Butt Weld Safety Assessment Meeting

MRP / NRC
September 11, 2003

Alloy 600 Issue Task Group (ITG)
Butt Weld Working Group

Butt Weld Safety Assessment Meeting MRP / NRC

Boric Acid Corrosion

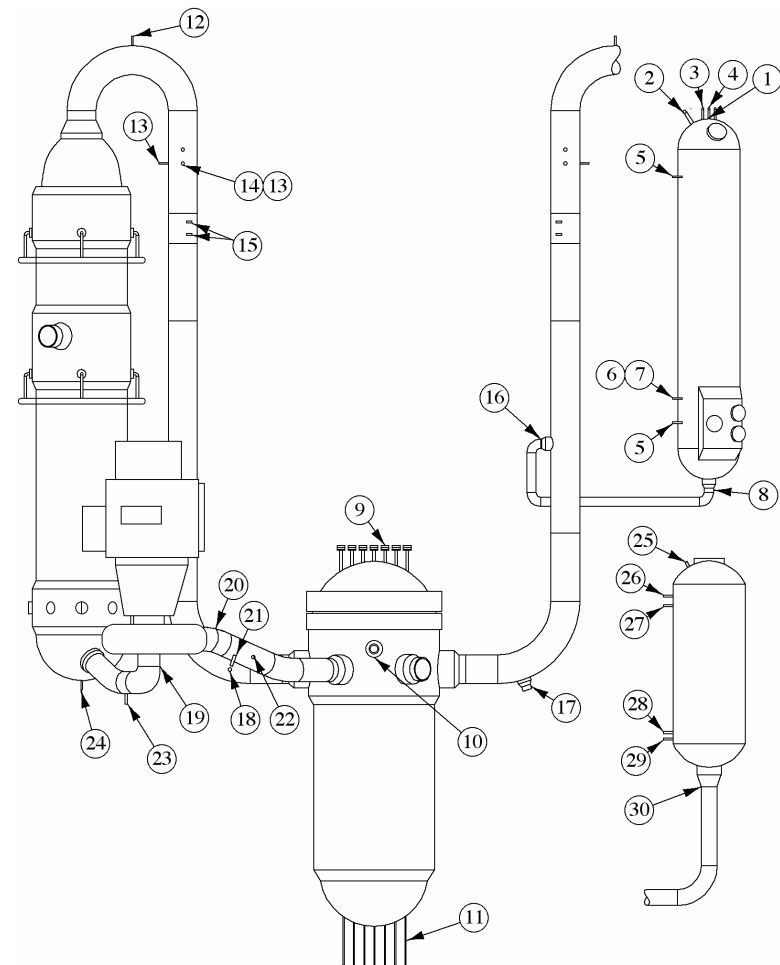
- *By letter from Sheron (NRC) to Marion (NEI) dated April 22, 2003, the NRC has questioned the conclusion that there is no concern with boric acid corrosion due to low leak rates from PWSCC cracks and high temperatures*
- Response:
 - The SA will address the issue of boric acid corrosion based on field experience and current analytical knowledge
